LISTED BUILDING
CONSENT

107 High St, Lindfield, Haywards Heath, West Sussex, RH16 2HR

Detail Drawings:
Removal of Internal Casement Windows

'As Built/ Proposed
First Floor Plan
Scale 1:25:A1
1:50@A3

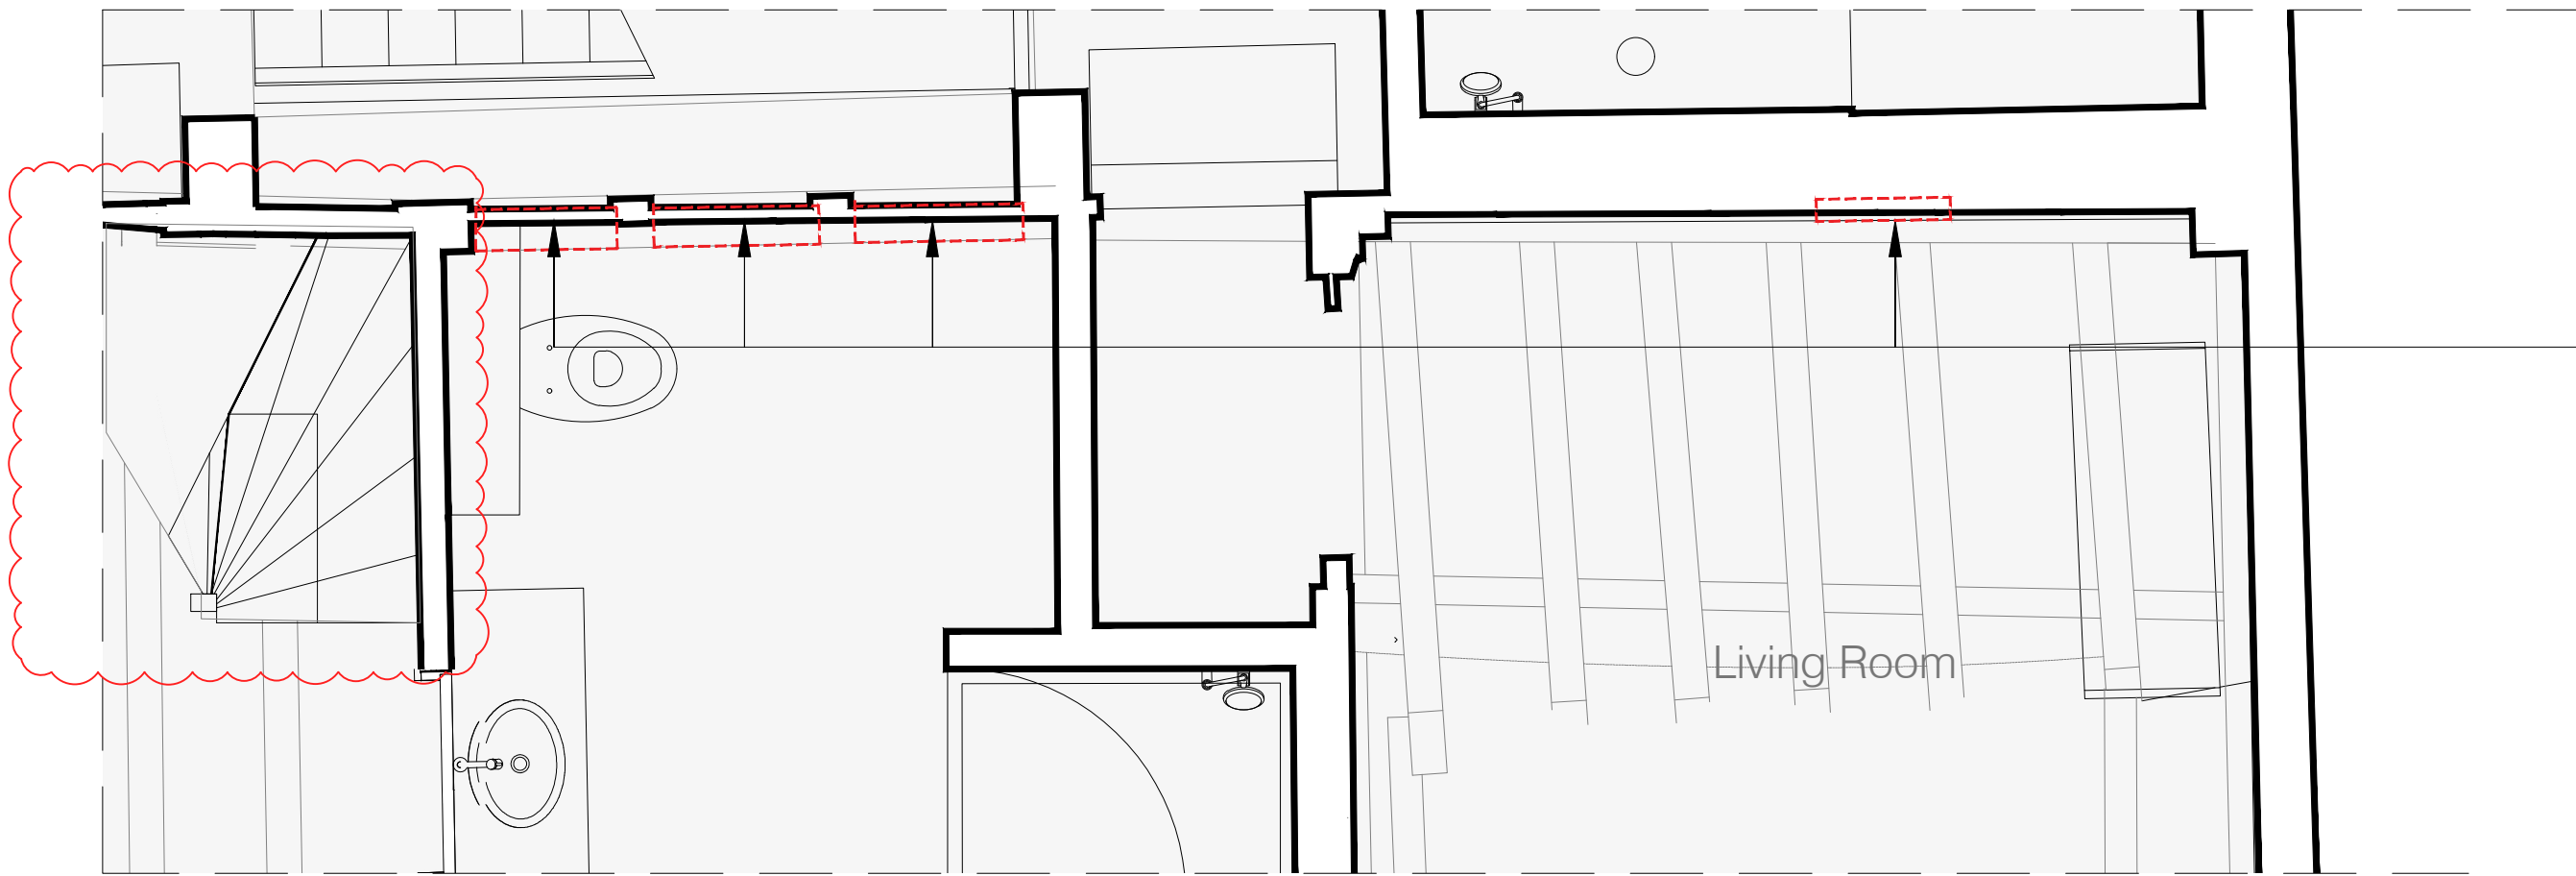
Existing, not original, casement windows to box framing of 15th century west wall removed. Openings filled in with timber stud framing, wood wool boards and lime plaster.

'As Built/ Proposed
Ground Floor Plan
Scale 1:25:A1
1:50@A3

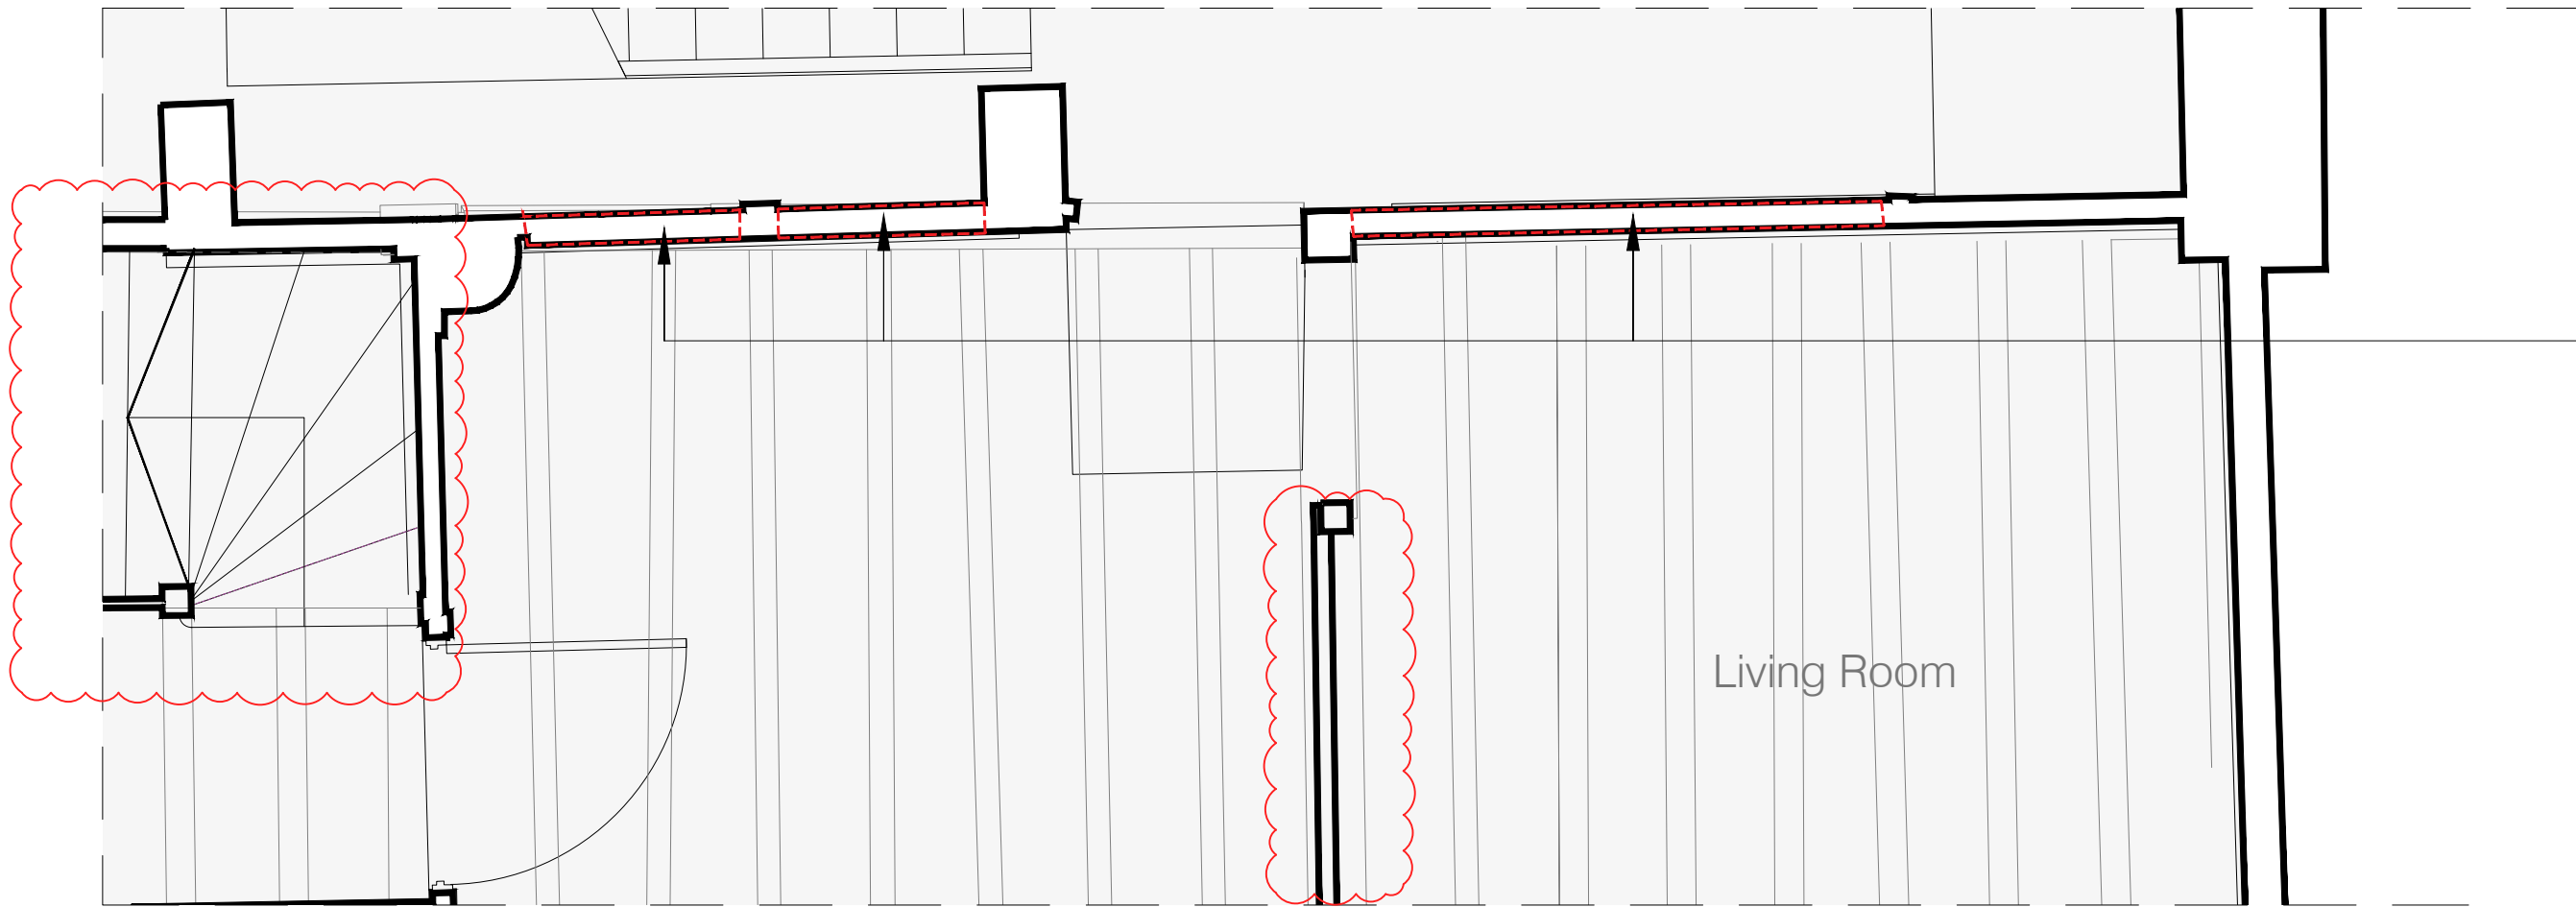
Existing, not original, casement windows to box framing of 15th century west wall removed. Openings filled in with timber stud framing, wood wool boards and lime plaster.
